RE: The Aurora Highlands Parkway Phase 2 Infrastructure Site Plan Response Letter

Variance Request Form

Subject: Variance Request
RSN # 1651542 | DN 2062-39 at 26th Avenue

Project typical section

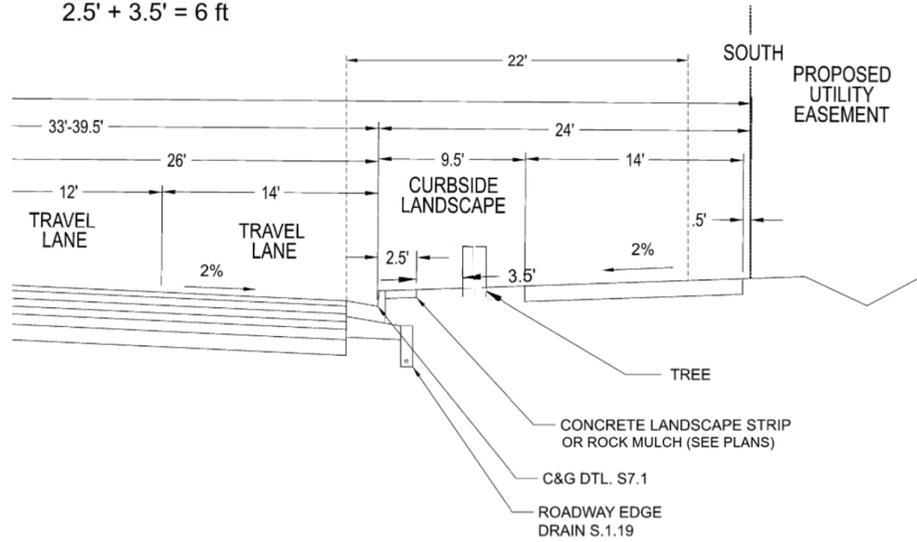
We discussed internally and we are fine with the 6-ft variance request. The dimension is shown from the center of tree and it should be shown from the edge of the tree. Can you please show the trees shifted about 6"-1' further from the road and resubmit? Also, please add Haley to the signature block (City Engineer)

- AECOM is unable to meet the City's 22-ft clear zone requirement referenced in the *COA 2023 Roadway Design & Construction Specifications (RDCS)* due to the PROS requirement to plant trees centered in the curbside landscape area. As reflected in the plans and drawings submitted to the City and attached herein, the trees are located 6 feet behind the curb, measured from the outside of the tree. Please refer to the Attachments below for greater detail.

$$9.5' + 14' + .5' = 24 \text{ ft}$$

$$2.5' + 3.5' = 6 \text{ ft}$$

Standard typical section from RDCS, Road Detail S1.5

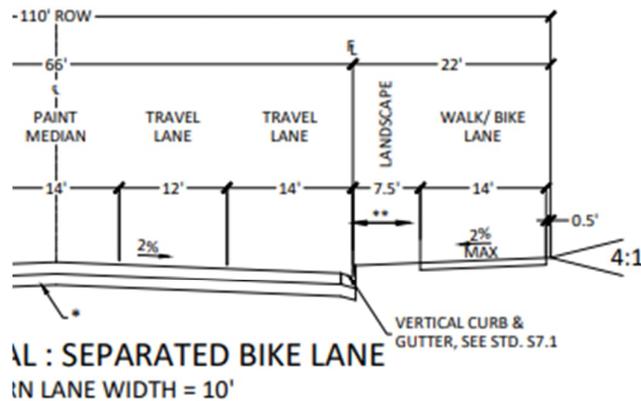
Standard Required: 22' clear zone required

Variance from Standard Requested: 6' clear zone provided
